ENVIRONMENTAL REVIEW TEAM REPORT

ROSSMORR ESTATES
HARWINTON, CONNECTICUT

JANUARY 1982

ENVIRONMENTAL REVIEW TEAM REPORT
ON
ROSSMORR ESTATES SUBDIVISION
HARWINTON, CT

FIGURE 2.

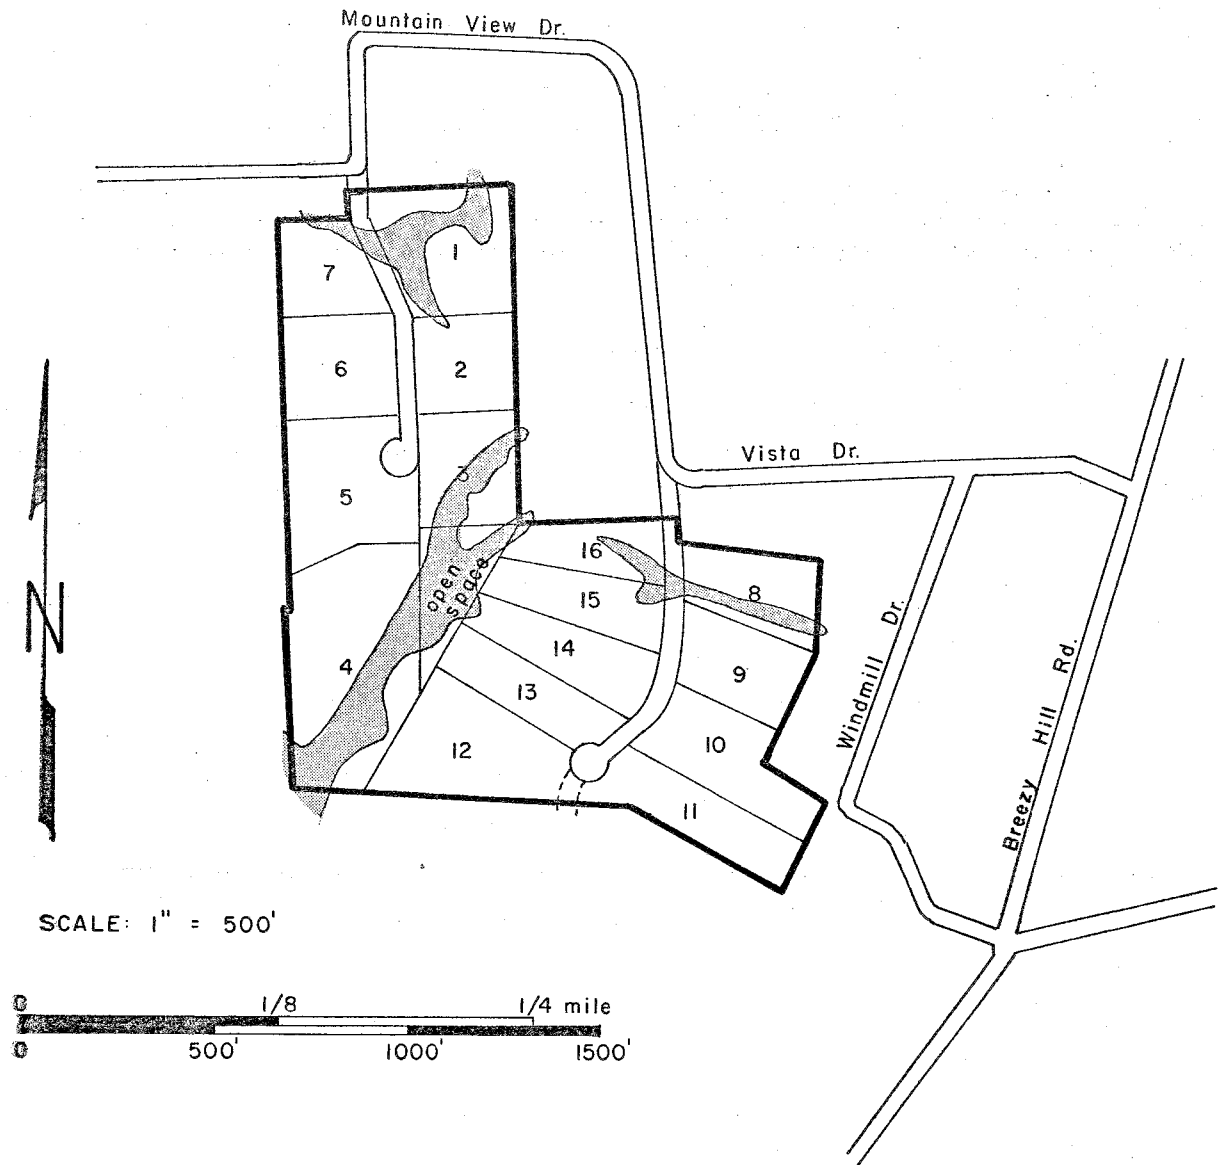
Phase 1 of the project consists of lots 1-7 as shown in Figure 2. According to the project engineers, plans for Phase 2 (i.e. the eastern half of the site) are still tentative. However, the project planners told the ERT that they are now considering the development of only 2-4 lots on this section (rather than the 9 lots shown in Figure 2) due to land limitations. All lots are to be served by on-site wells and septic systems.

Access to Phase 1 is available off Mountain View Drive. An interior road of + 800 feet is being proposed off Mountain View Drive to service the seven proposed lots. Access to Phase 2 of the project is available off Vista Drive and/or Windmill Drive.

1. A considerable portion of lots #1, 3 and 4 is mapped as inland wetland soils. The surrounding soils are of the Paxton-Woodbridge series. Due to the wet nature of these soils, extreme caution is advisable in the design and placement of septic systems to ensure operability.

3. Lots #2 and 5 are mapped as Paxton and Woodbridge and should be managed as such.
4. A properly designed culvert crossing should be installed where the proposed road crosses a narrow wetland area near the proposed entrance to the property.

5. The possibility of draining the wetland area on the north side of the property (near the proposed entrance) was discussed during the ERT's field review. It appears that several subsurface drainage lines spaced about 75' apart would be necessary to drain the relatively small area mapped as wetland. However, due to the amount of wetness in the surrounding areas, it is questionable as to whether the wetland area would be dried up even after drains were in place.

FIGURE 3.
DRAINAGE AREA OF ON-SITE STREAM

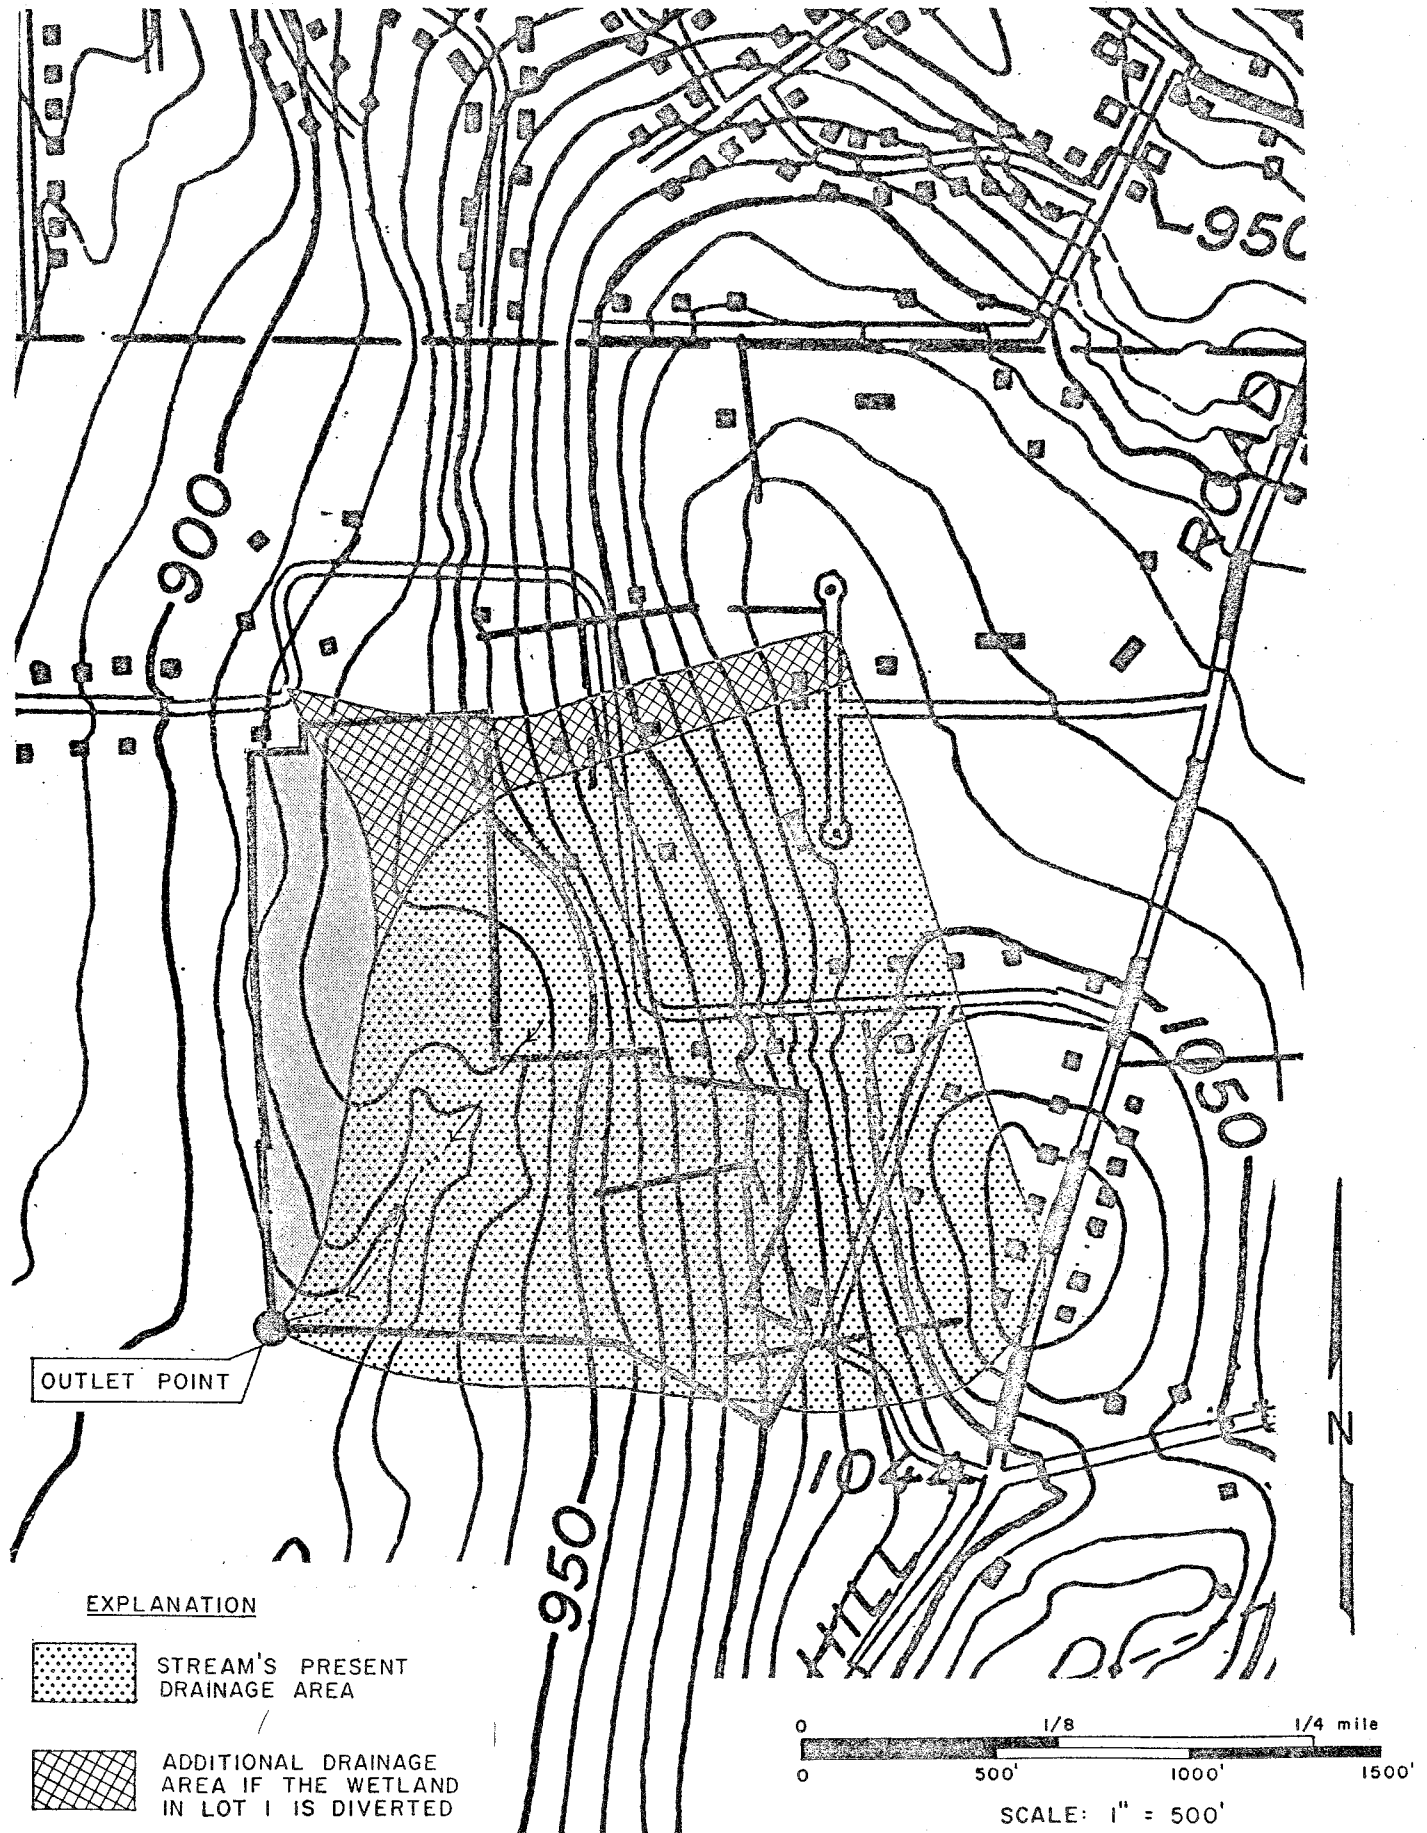
of approximately 60 acres. If the narrow wetland in lot 1 is diverted through the access road to Phase 1, as the developer proposed, the effective drainage area would be increased by about 6 acres (see Figure 3).

As a result of runoff increases from the proposed development, peak flows in the site's central stream would increase. Again, however, the relatively low density of the subdivision would tend to minimize the effect, even with the diversion of the lot 1 wetland. If Phase 1 only were completed, peak flows for a 2 year frequency storm would increase by only about 5 percent, while peak flows for the 50-year and 100-year storms would increase by only about 1 percent. If both Phases 1 and 2 were completed (including all of lots 1 through 16), peak flows for a 2 year storm would increase by about 22 percent, while increases for a 50-year or 100-year storm would increase by about 5 percent. Phase 2 would have a greater influence on the storm flows because of its steeper slopes and because of the greater number of lots that would lie within the stream's watershed.

in or near the wetlands. For this reason, the Team Geohydrologist recommends a setback of at least 50 feet. Special care should also be used in both the design and the installation of septic systems in areas having seasonally high groundwater levels.

FIGURE 4.
VEGETATION TYPE MAP

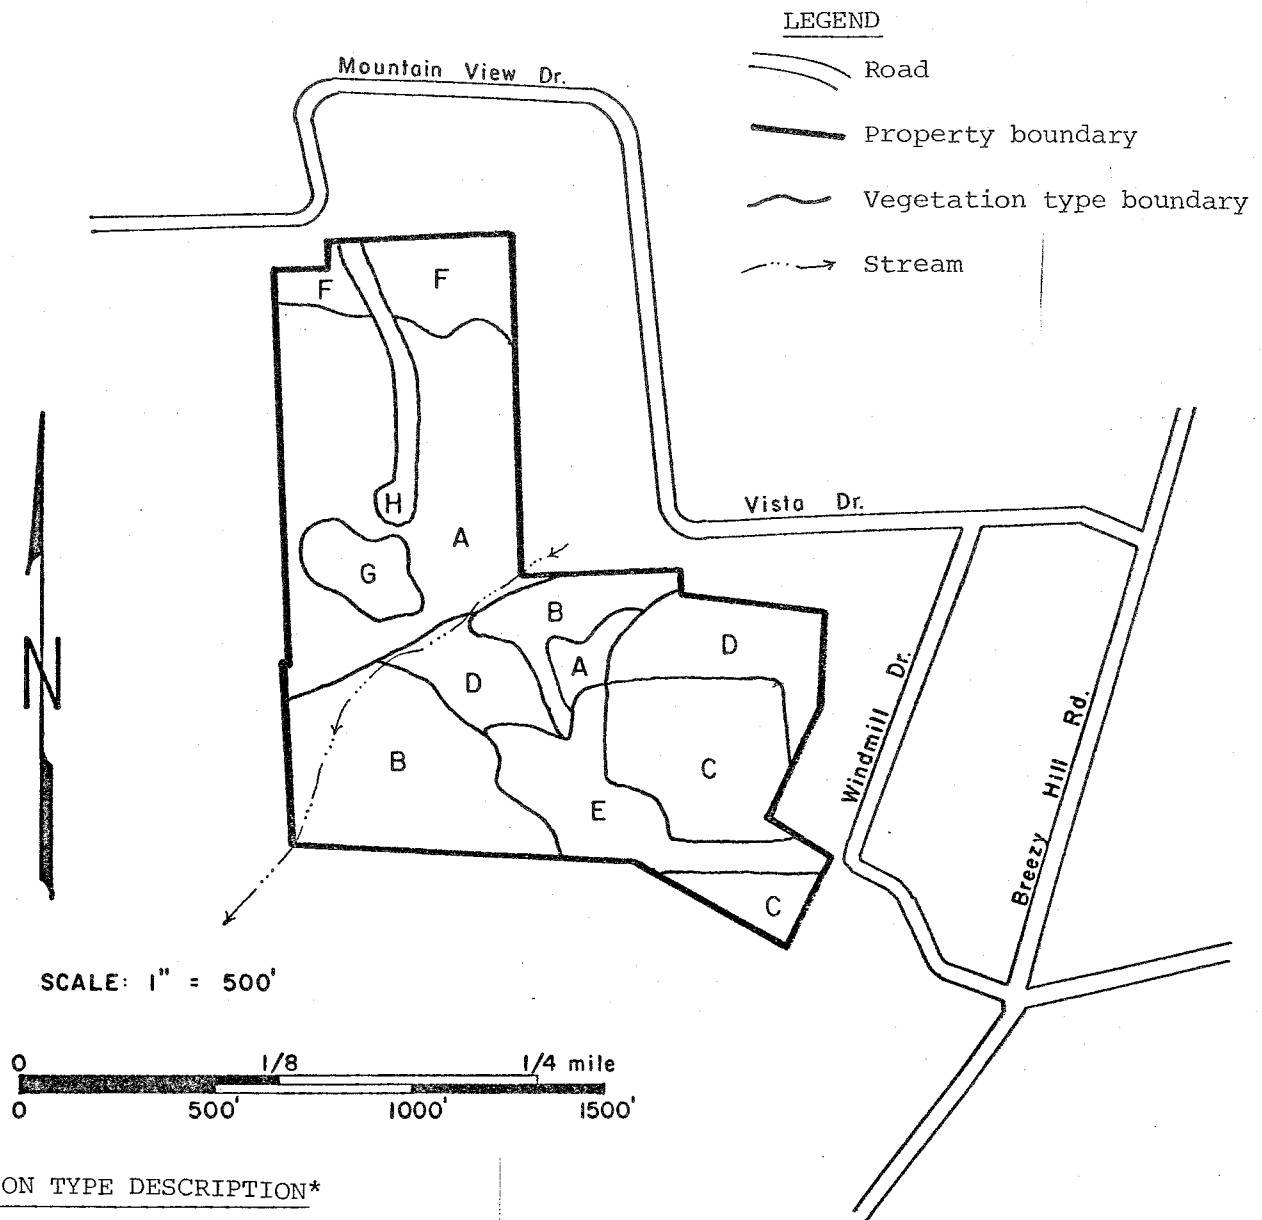
Many of the large healthy trees which are scattered throughout vegetation types A, B, E and G have high aesthetic and shade value. These high value trees should be selected for retention and worked into the final site plan for the proposed development. Several trees found within vegetation types A, E and G (which include paper birch and eastern white pine) would make excellent specimen trees. Recent research has shown that trees on a house lot may enhance the value of that house lot by as much as twenty percent.

Many of the trees which are present in vegetation type E (mixed hardwoods) are very low in quality. Broken tops, split seams and extremely poor form is characteristic of many of these trees. These trees will represent a potential hazard if they are not removed prior to development.

Windthrow is a potential hazard in parts of vegetation type F, and also along the stream which passes through this property. Tree root depth is restricted by saturated soils in these areas. Under these conditions trees are unable to become securely anchored and are susceptible to windthrow. Trees which are crowded and rely on each other for stability have an even greater potential for windthrow problems and top breakage. These conditions may be intensified if linear openings, which allow wind to pass through rather than over these areas, are made. Openings and clearings in and along side these wetland areas should be avoided if at all possible. Light thinnings in these areas may help to improve tree stability however.

The trees which are present in vegetation types D and F are declining in health and vigor as a result of their crowded condition. Under these circumstances the trees are under stress, and major disturbances in their environment, such as changes in soil conditions and mechanical injury caused by construction in this area, may rapidly lower their health. A fuelwood thinning in these stands, following the "crop tree selection method" (preferably prior to construction) would help to reduce the crowded condition and improve health and

Although the trees which are present in vegetation types A, B and E are not rapidly declining in health and vigor, their overall condition could be improved by removing some of the poor and damaged trees for fuelwood. Thinnings focused on the removal of undesirable trees will once again reduce crowding and competition between residual trees. Up to one-third of the trees which are present in the overstory could be removed for the purposes of this thinning. Healthy, high quality trees should, however be retained.

SOILS MAP

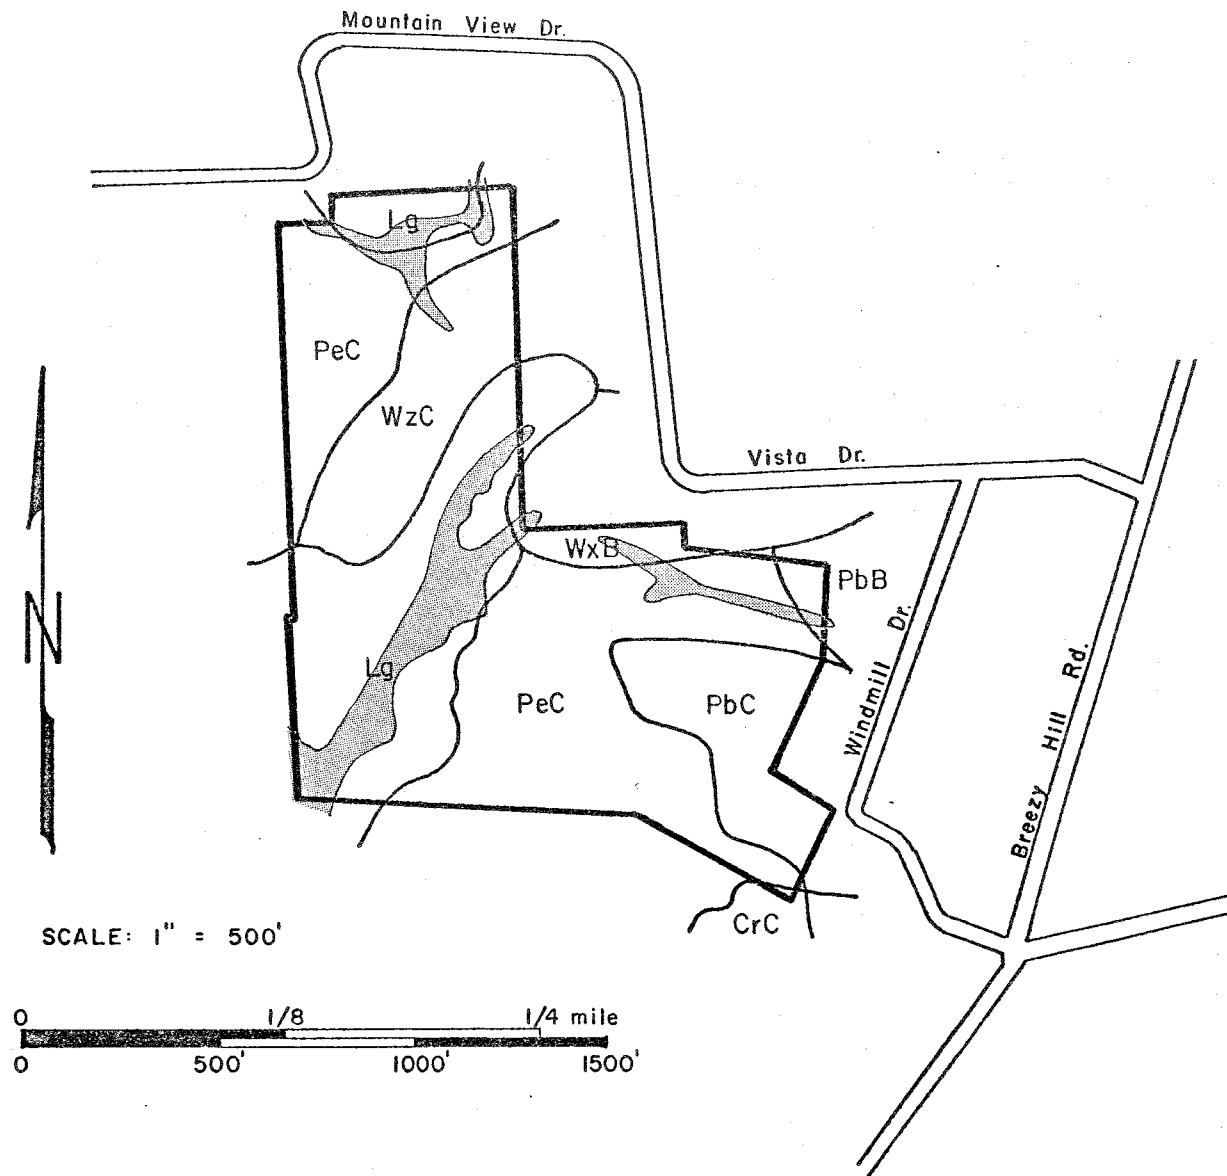
During the site investigation it was noted that included within the area mapped as Paxton very stony soils, 3-15% slopes (PeC, located on the northwestern portion of the parcel) was a considerable area of soil that had no definite hardpan layer to a depth of 4-5'. This was observable as several deep hole test pits had been left open. More test pits could be dug to determine whether to manage this area as a Paxton soil or as a soil with no hardpan layer, such as Charlton.

2. Portions of lots 6 and 7 (although they are mapped as Paxton and Woodbridge) appeared to have no definite hardpan layer within the top 4-5'. However, the extent of this situation can only be determined by further on-site investigation. If no further on-site investigation (test pits) is carried out, it would be best to assume that this area is a small inclusion of another soil within the Paxton or Woodbridge mapping units.
